Limerick Generating Station

Units 1 and 2

Technical Specifications Change Request

No. 97-04-0

1-10

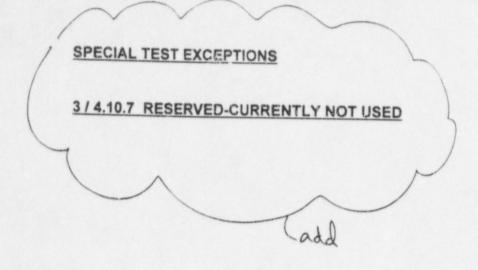
*** * See Special Test Exception 3.10.8 -add
